UNITED STATES PATENT AND TRADEMARK OFFICE

10/501,938

Office Action Summary	Application No. 10/501,938	Applicant(s) SEVERINI, JOSEPH	
	Examiner Tan Le	Art Unit 3632

DETAILED ACTION

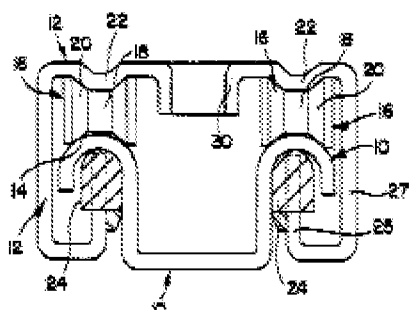
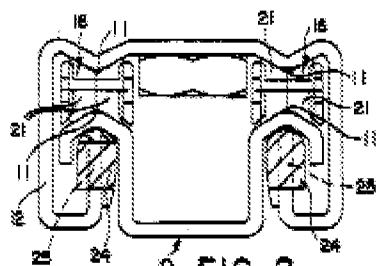
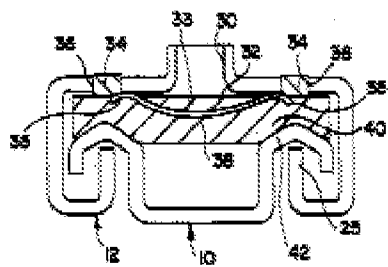
Brandoli et al. discloses all of the limitations of the claimed invention except for the flattened bearing surface. DeVoss et al. teaches the inner track having a bearing surface, which is flattened bearing surface (30, 34 Fig. 4) extending longitudinally along the inner track for smooth sliding movement between outer track and inner via planar surfaces 64 of the bearing retainer body assembly 58 (see attached Figure 4).

As to claim 2, wherein said inner track includes two upright sides (see attached figure) and a cross member extending laterally there between to define a U-shaped channel, said sides each having a distal end opposite said cross member.

As to claim 5, wherein said inner track includes an outer wall extending substantially perpendicularly from each of said outer edges to define a flange (see attached figure).

As to claim 7, wherein said outer track includes two upright sides and a base (see attached) extending laterally between said sides to define a U-shaped cross section, said sides of said outer track each including a distal end.

As to claim 8, wherein said base of said outer track includes a concavity (see attached figure) formed therein, said concavity protruding toward said inner track to define said arcuate bearing surface opposing said flattened bearing surface.

With respect to Applicant's argument stating that "the horizontal segments 34 of the outwardly-bent flanges 30 on the lower track 14 in the '076 reference are not equivalent to the flattened bearing surfaces (37, 38) in the above-captioned application.

In fact, the horizontal segments 34 of the outwardly-bent flanges 30 on the lower track 14 are not bearing surfaces..." (Page 12, first paragraph). The examiner respectfully disagrees because of the following reasons: First the horizontal segment 34 of DeVoss et al '076 is a flattened bearing surface because it facilitates a relative movement in the fore and aft directions between the upper track and lower track where a pair of retainers assembly are interposed between each set of interfitted upper rack and lower rack for enabling smooth sliding movement of upper track and lower track along a substantially horizontal plane 34 (col. 4, lines 15-19). Thus DeVoss et al ('074) teaches that a flattened or horizontal surface 34 is a flattened/horizontal bearing surface. Second, DeVoss et al '076 has been applied for their teaching of providing a flattened bearing surface. Brandoli et al. '504 is the primary reference, not a secondary reference and DeVoss et al ('076) has been applied to one skilled in the art would reasonably be expected to draw the teaching therefrom. In addition, there is no requirement for a secondary reference to meet every limitation of the claim before it can be utilized. A combination of references is proper for any reason taught by the prior art, not just applicant's reason. The rejection was based on the combination of Brandoli et al in view of DeVoss et al. Applicant cannot show nonobviousness by attacking references individually where the rejections are based on combinations of references. Accordingly, this action is made FINAL.
